## TECHNICAL MEMORANDUM

**FROM:** John Sigda, Ph.D. and Eileen Marcillo, INTERA Incorporated

**TO:** Rick Shean, Water Quality Hydrologist, Albuquerque Bernalillo County Water Utility Authority (ABCWUA)

**SUBJECT:** Review Findings for RCRA Facility Investigation Report Bulk Fuels Facility Release Solid Waste Management Unit ST-106/SS-111 dated January 2017

Figure 11  
Partially Corrected Data Set for  
Non-Degradation Mechanisms at  
KAFB-10610  
ABCWUA

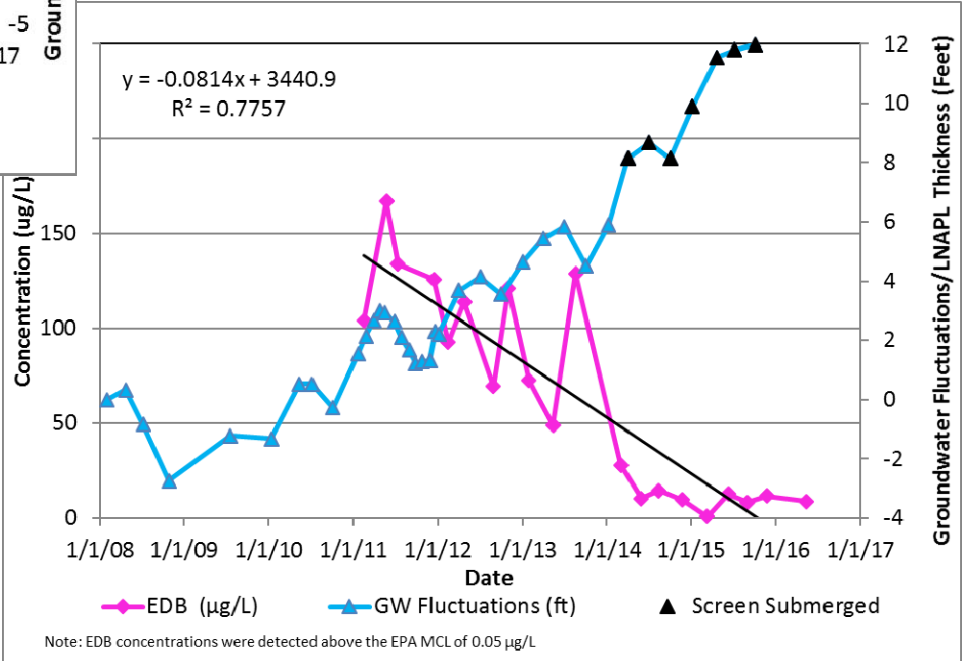
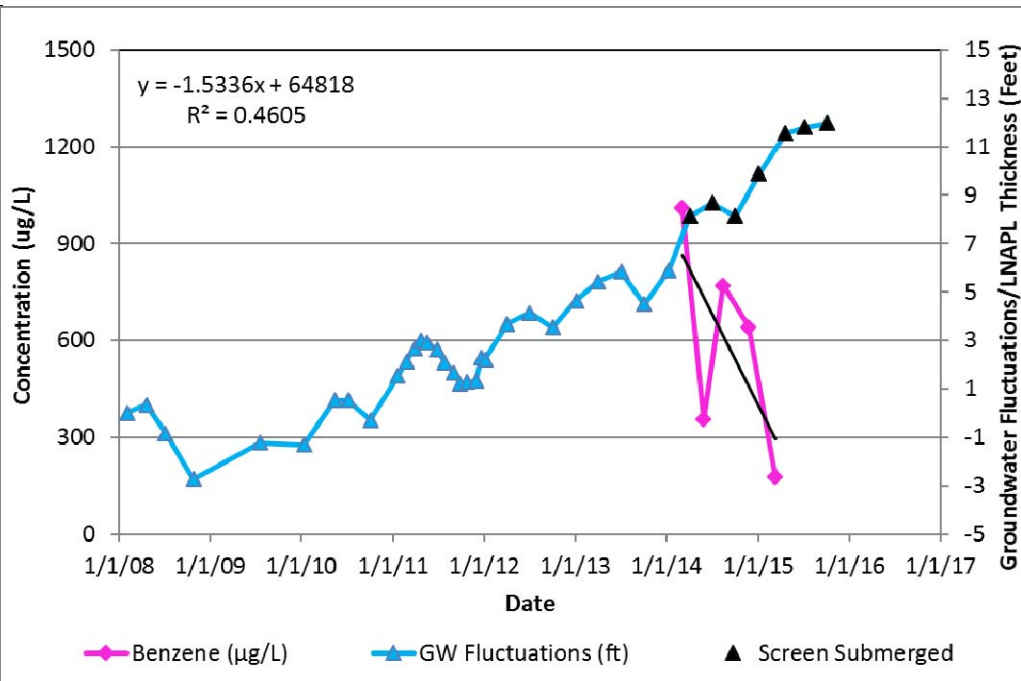
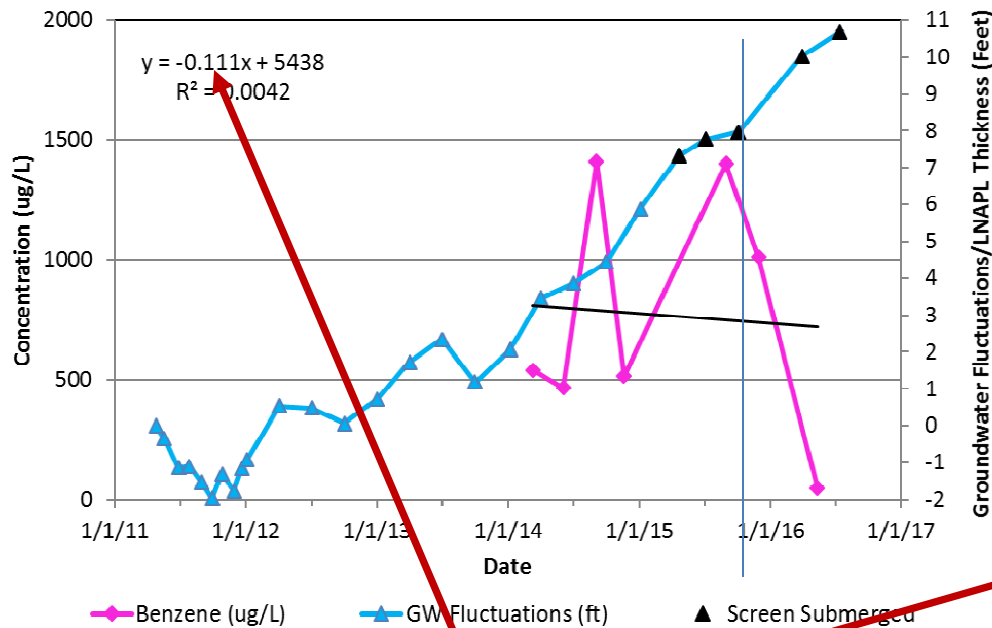
How much of the EDB concentration decrease from late 2013 to present was caused by the large increase (about 8 feet) in water level?

Figure 12  
Partially Corrected Data Set for  
Non-Degradation Mechanisms at  
KAFB-1065  
ABCWUA

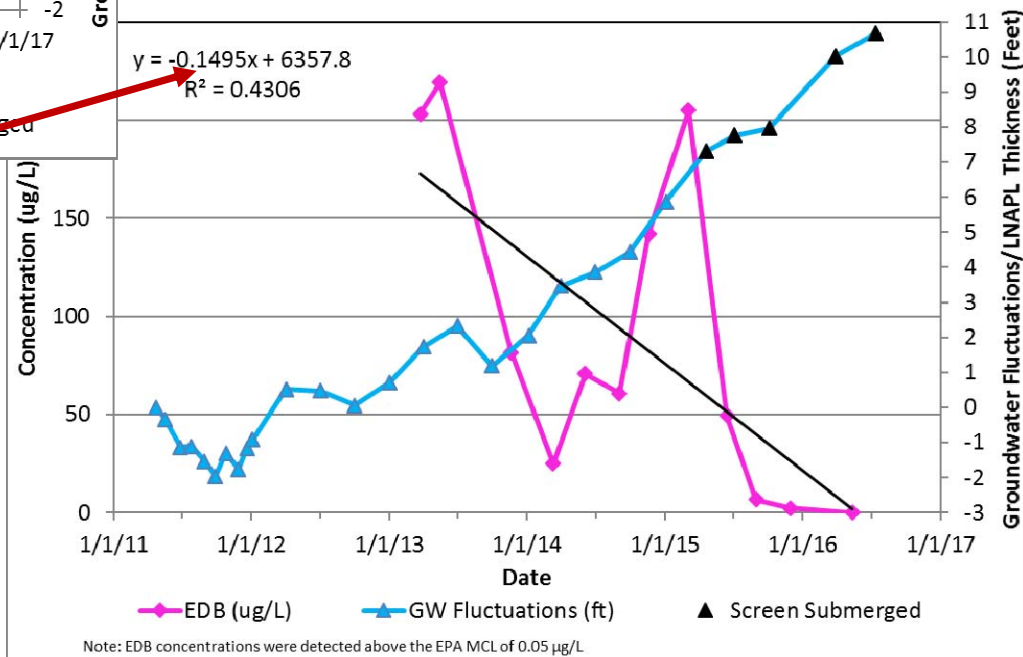
Are the recent decreases caused more by drowning than degradation?

Slopes (rates of change) are fairly flat (zero) for correct data sets

Figure 13  
Vertical Gaps in Screened Intervals  
at Distal EDB Plume  
ABCWUA

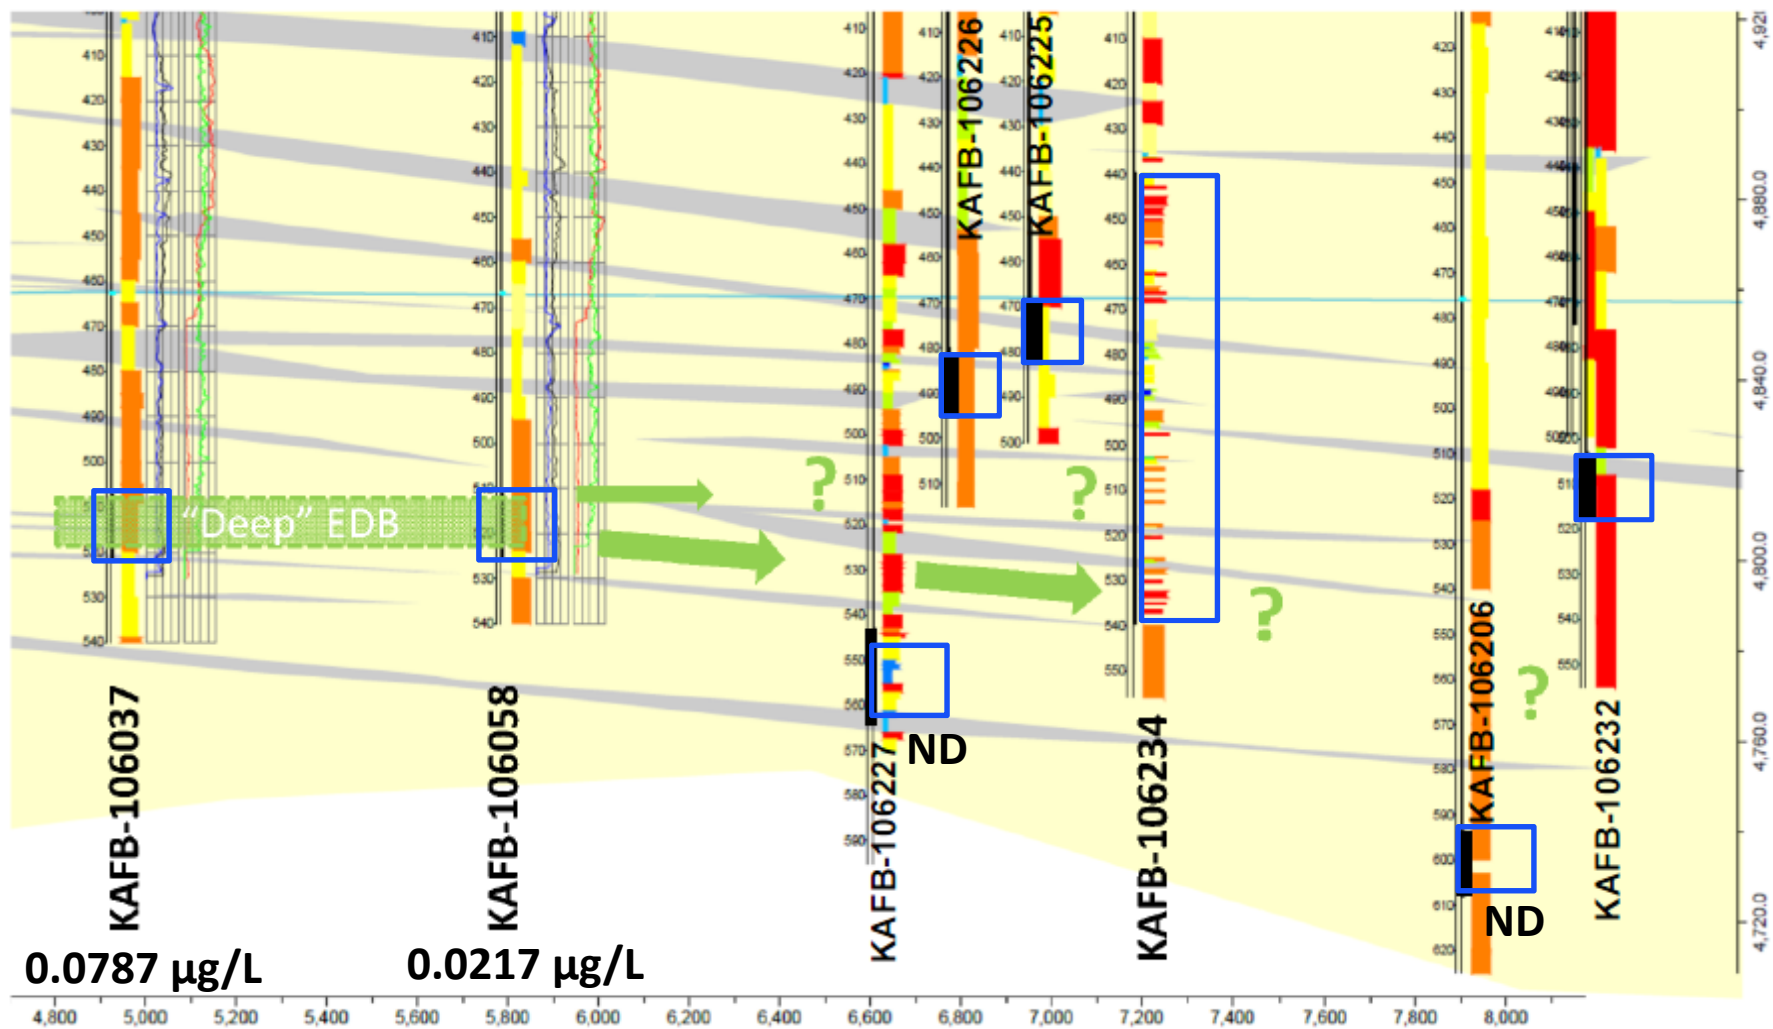
The RFI report states that the horizontal extent of the EDB groundwater plume is well defined except for the data gap at the northwest margin of the plume. We agree that there is a data gap at the northwest margin of the plume, but there much more important data gaps in the vertical extents of the EDB plumes. The vertical extent of the distal EDB plume at depth remains undefined. The deepest EDB was detected at monitoring wells KAFB-106037 and KAFB-106058 for a number of years, with concentrations that were several to many multiples of the MCL. A recent cross-section created by Colin Plank of AECOM in April 2016 from those wells northward to the extraction well KAFB-106234 is shown in **Figure 13**. The deep screen location (KAFB-106227) at the next cluster downgradient of KAFB-106058 is about 55 ft below the screen for KAFB-106058 and there are one or more silt-dominated intervals that may have acted to divert plume migration, leaving question about the EDB location (**Figure 13**). The most downgradient deep screen, KAFB-106206, is about 70 below the bottom of the KAFB-106058 screen and could be isolated from EDB migration by a slightly thicker silt-dominated interval (**Figure 13**). Similarly, the screen bottom for intermediate monitoring well KAFB-106232 is about 70 ft above the top of the screen for KAFB-106206 (**Figure 13**). These vertical gaps between the monitoring well screens and the location and orientation of the silt-dominated intervals demonstrate there is an important data gap about the EDB plume with depth. The data gap extends to locations downgradient of the most distal extraction well (KAFB-106234) and so should be resolved as soon as possible before finalizing the extraction well system.

The upper vertical extent of the groundwater contaminant plumes is no longer defined and is increasing as the water table rises. Most of the shallow screened intervals in the monitoring well network within the source area have been submerged for a few years. The high concentration part of the EDB plume is now located above the tops of these screens, so it is not possible to know the extent of the plume. Furthermore, the rising water table may be intercepting fuel LNAPL in the deep vadose zone, which may cause dissolved phase concentrations to increase significantly. Consequently, the RFI should be revised to describe these vital data gaps and all text about shrinking or stable plume size should be removed from the current document.
